Review of Kimley-Horn Sediment Transport Model of the Agua Fria River

Prepared for:
Flood Control District of Maricopa County

WEST Consultants, Inc
2151 East Broadway Road, Suite 116
Tempe, AZ 85282

January 10, 2002

RS = 17.638

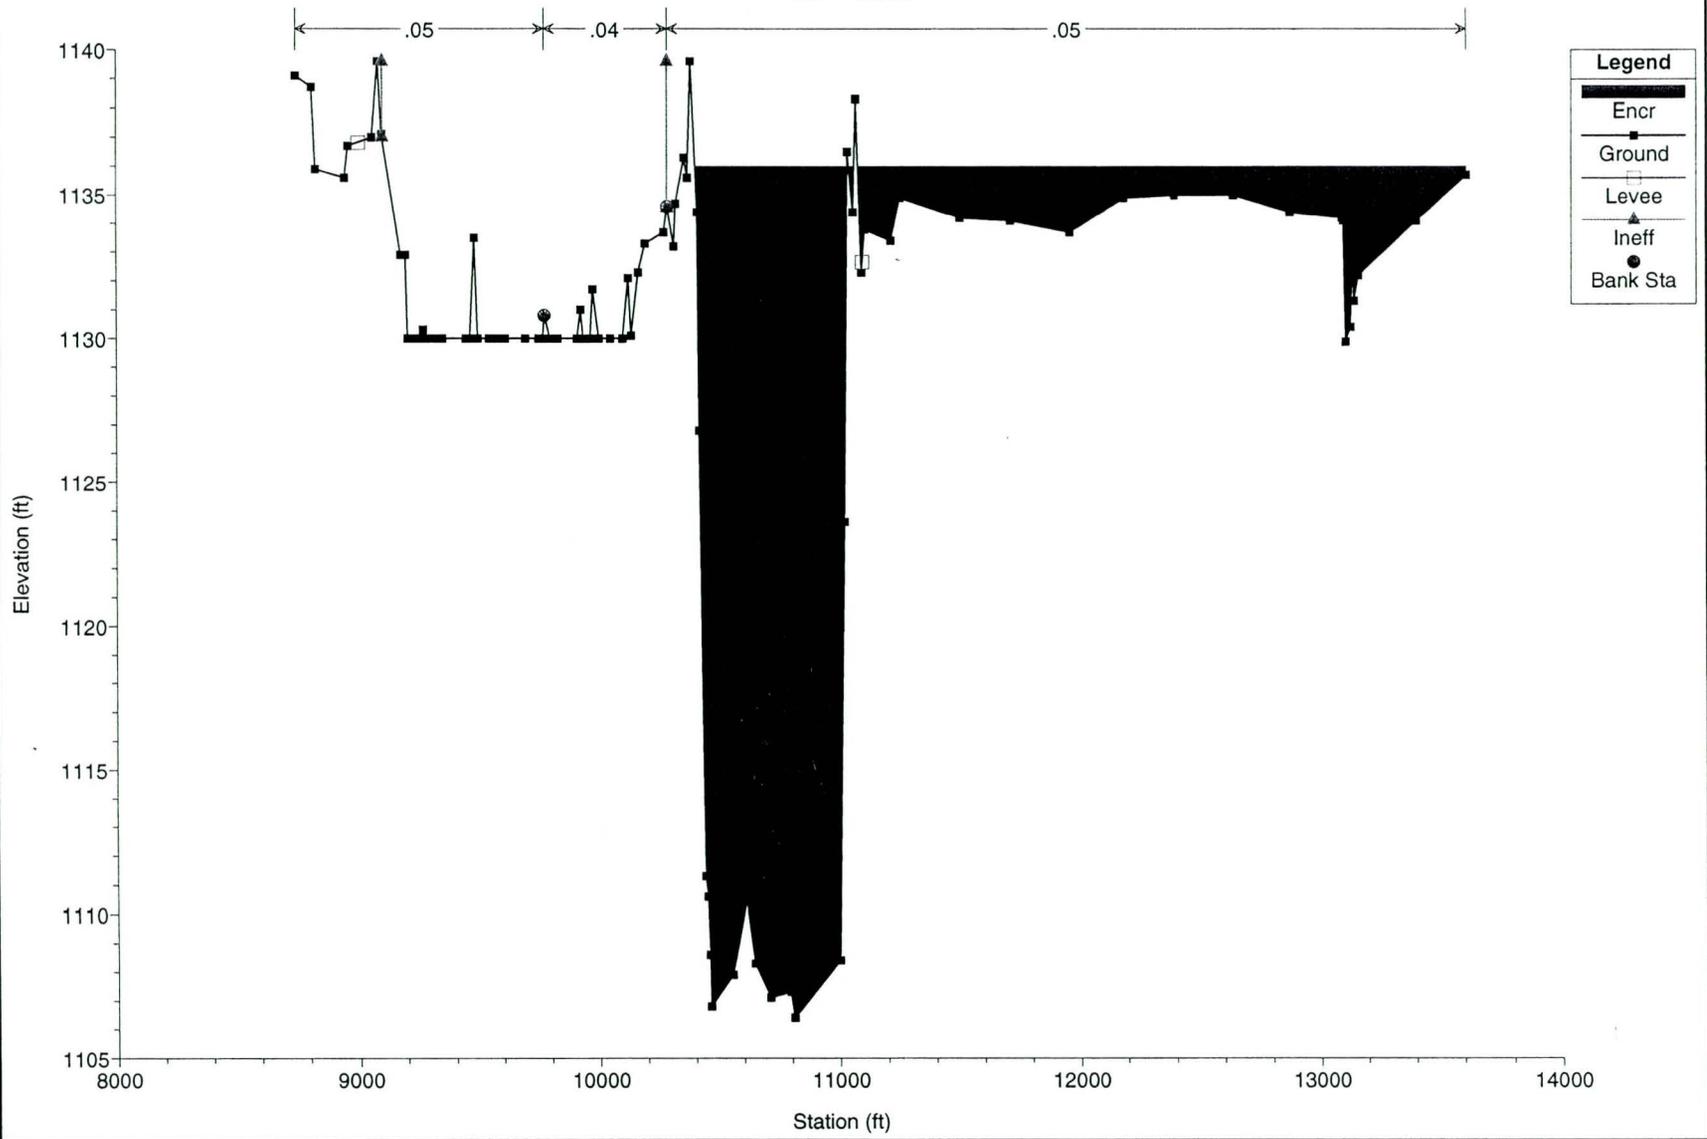
cross sections be introduced at other locations where an abrupt change in velocity occurs (e.g. cross section 32.998, 30.73, 30.07, 17.638, 15.374, 11.428, etc.).

RS = 16.506

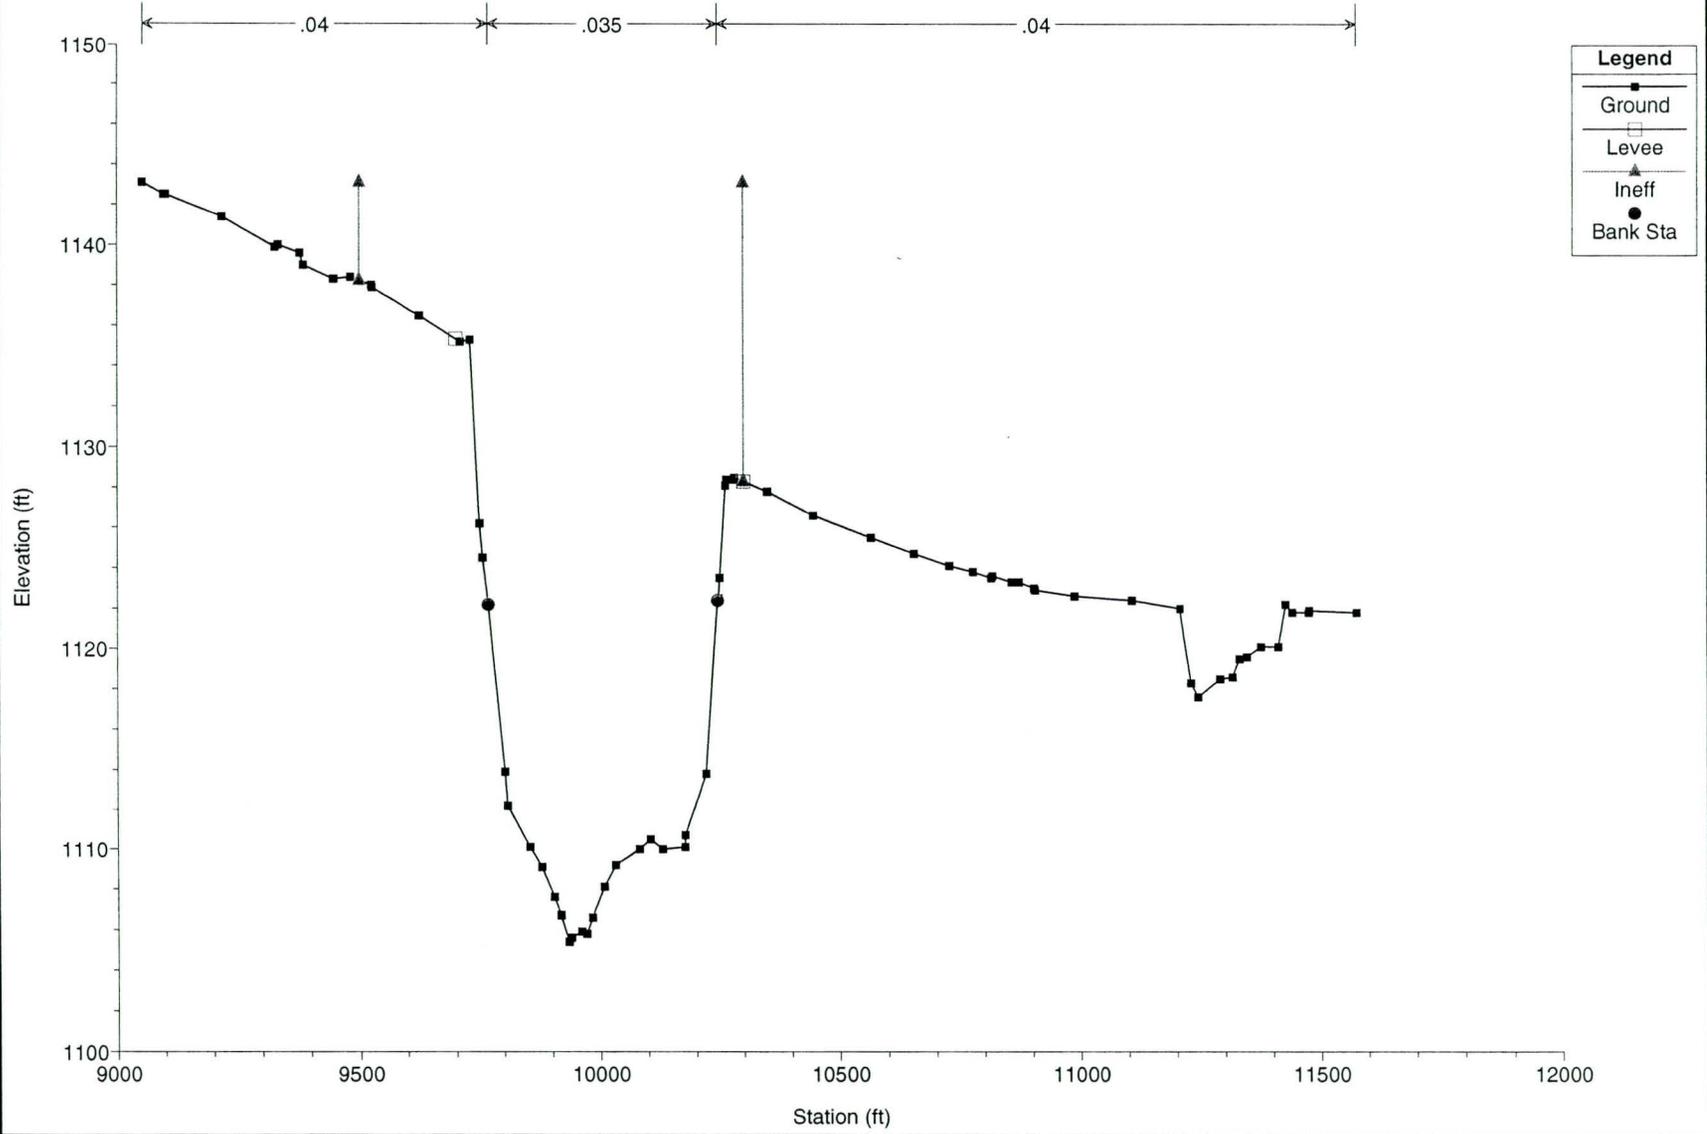
Several cross sections should have encroached areas specified (by X3 record) behind what appear to be levees. For example: cross section 8.105 for both berms/levees (Figure 2); 15.0, 16.506, and 21.157 (Figure 3) for the right levee. The "levees" on the left side of cross section 8.105 appears to be a road embankment and flow in that area should have been set to be ineffective. There is no X3 or XL card for this cross section however. It should also be noted that the cross section geometry appears to be different when a comparison is made between Figure 2 and the same cross section in the Appendix which shows the existing conditions base movable bed model. Similar problems need to be resolved at the other cross sections listed above.

RS = 15.374

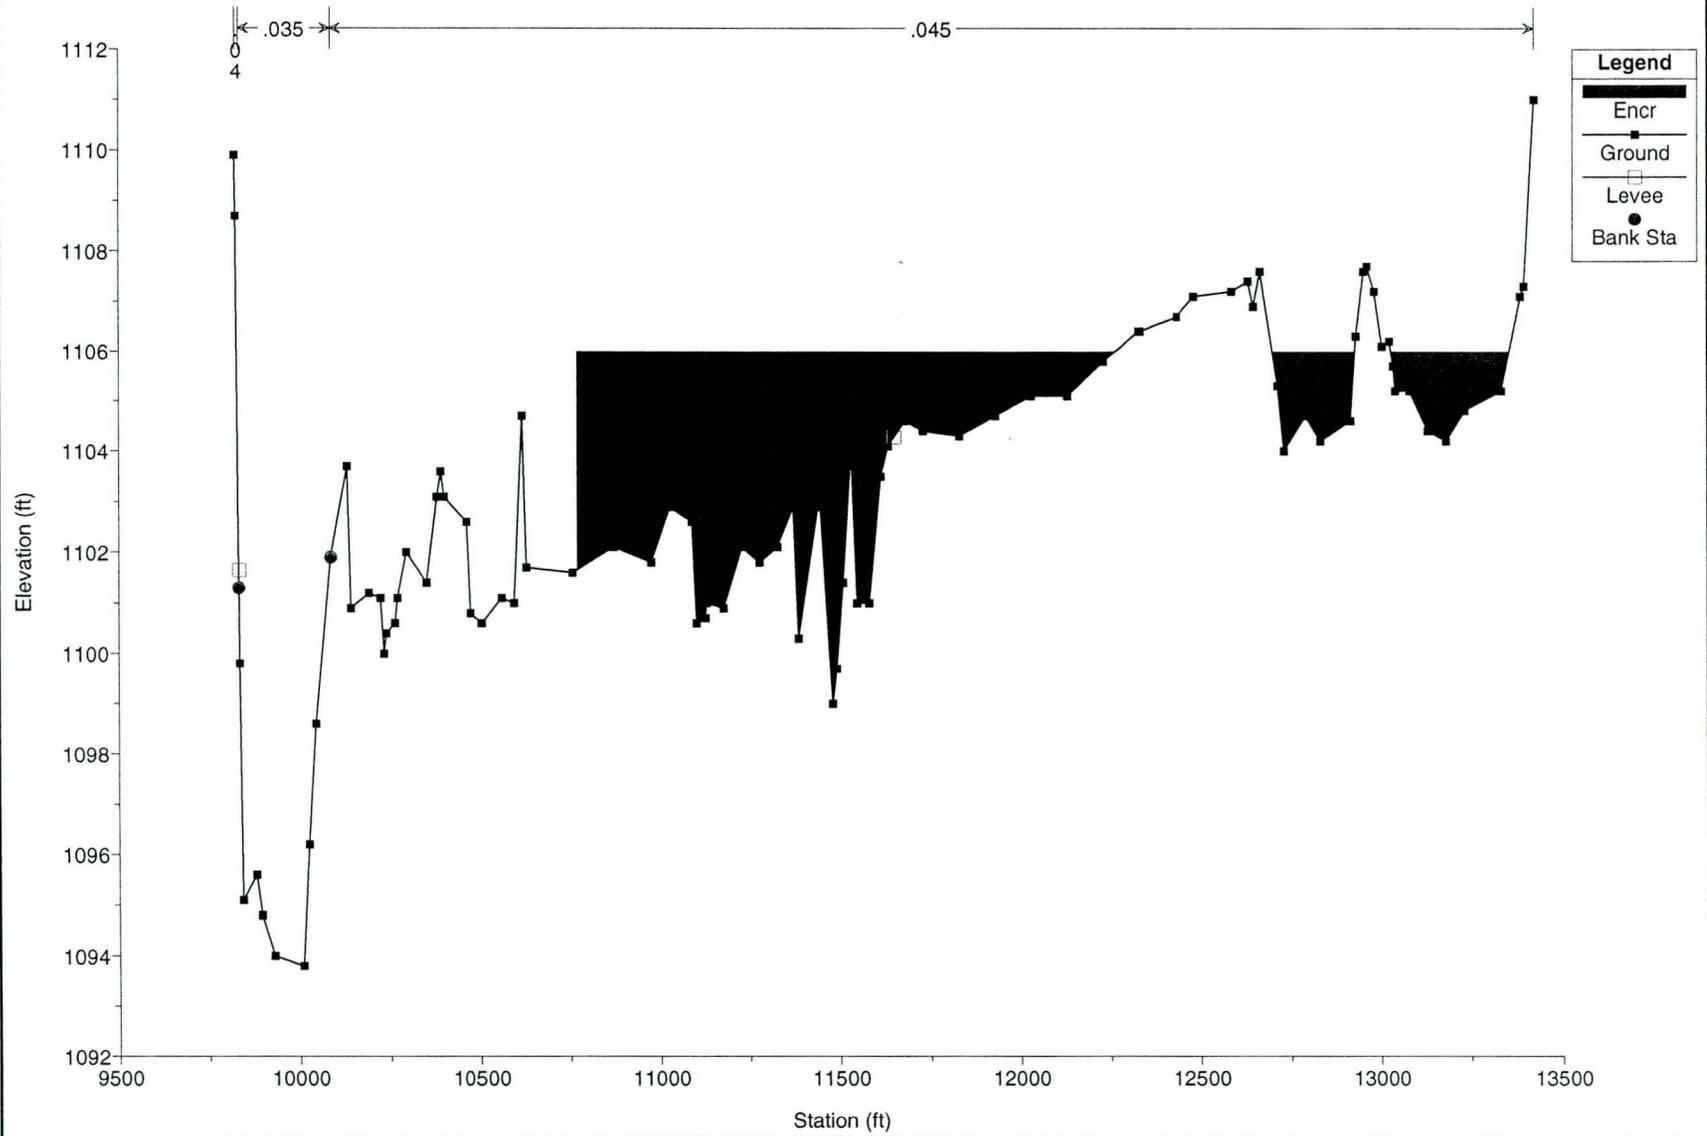
Significant expansion and contraction of the water surface width was noted at several cross sections (e.g. 1.33, 3.43, 15.374, 25.666, 32.92 as well as others). The expansion ratio should generally be limited to 3:1 (3 streamwise units to 1 lateral unit) and the contraction ratio should generally be limited to 1:1 by setting ineffective flow or conveyance limits (X3 or XL records) where appropriate. The cross sections listed above appear to be in violation of these recommendations.

RS = 12.359

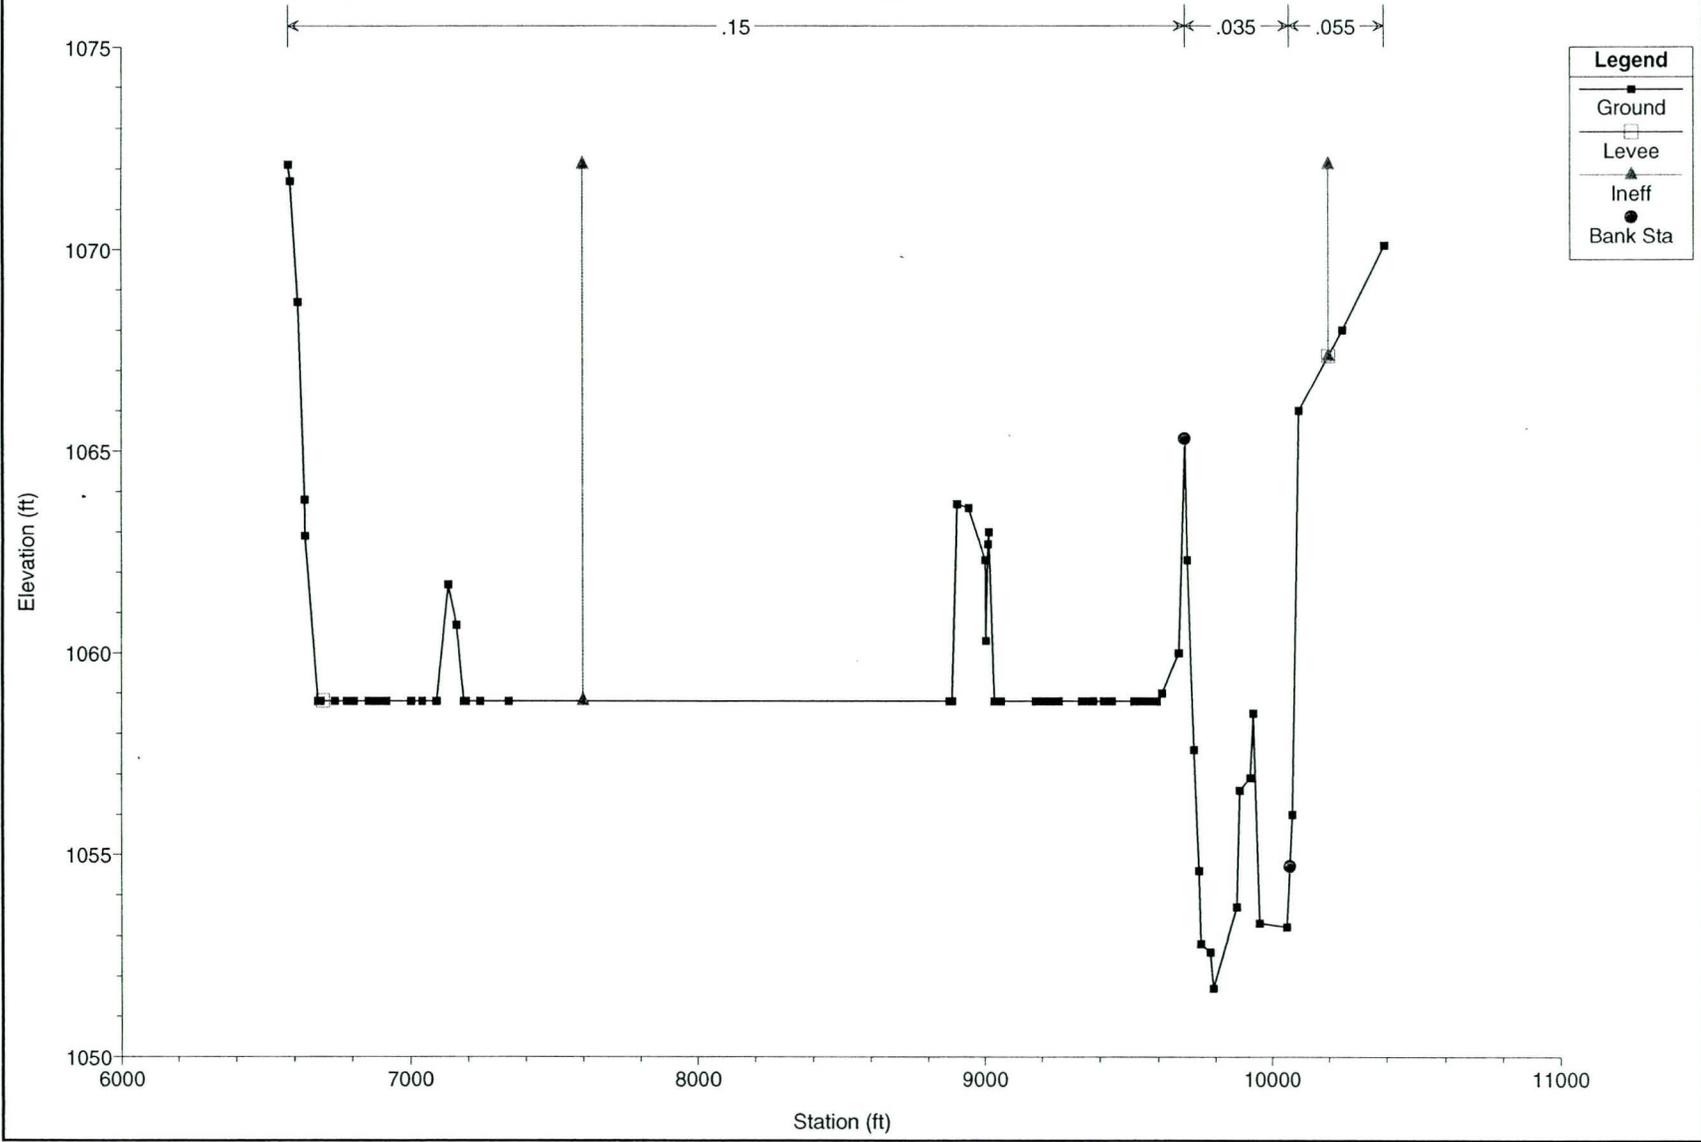
need to be set up by conveyance limits that restrict erosion within the channel (banks), allowing deposition in the overbanks. An example of this is cross section 12.359 (Figure 9) which seems to be setting an ineffective flow area downstream of the Northern Avenue Bridge.

RS = 6.91

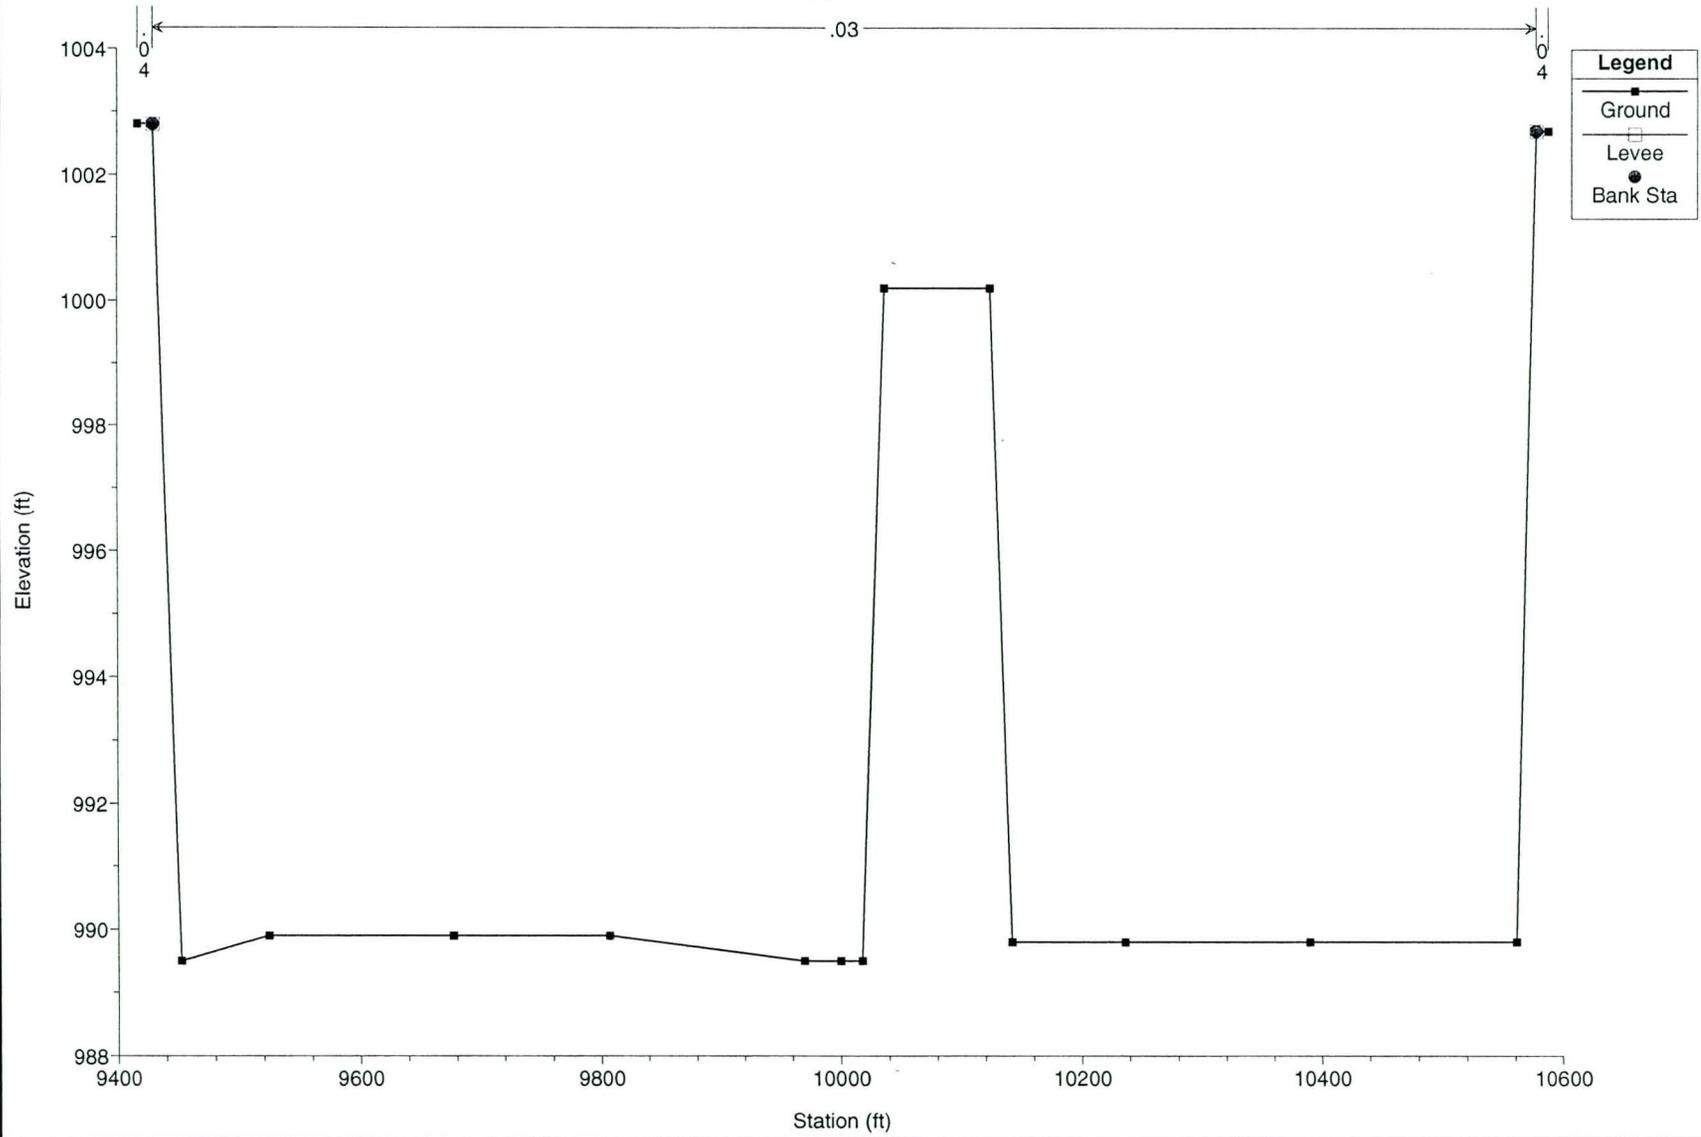
Discontinuous features in the channel geometry (e.g. structures, high ground) should also be defined by ineffective flow or conveyance limits (X3 or XL records) both upstream and downstream when the influence is seen at the upstream and downstream cross sections. An example of this is a feature at cross section 6.91 which is not seen in either the upstream or downstream cross section (Figure 1). This feature is a protected electrical transmission tower but should appear in the downstream cross section which is only 10 feet below the tower according to the input file. The influence would probably not be noticed upstream (cross section 6.93) where the distance is larger than the diameter of the tower base (e.g. a 1:1 contraction) but should be modeled in cross section 6.89. The influence of this tower may not be extremely important in cross section 6.89 but it appears the cross sections were designed to model the influence of the towers in this reach of the river. Currently however, the influence is limited to only cross section 6.91.
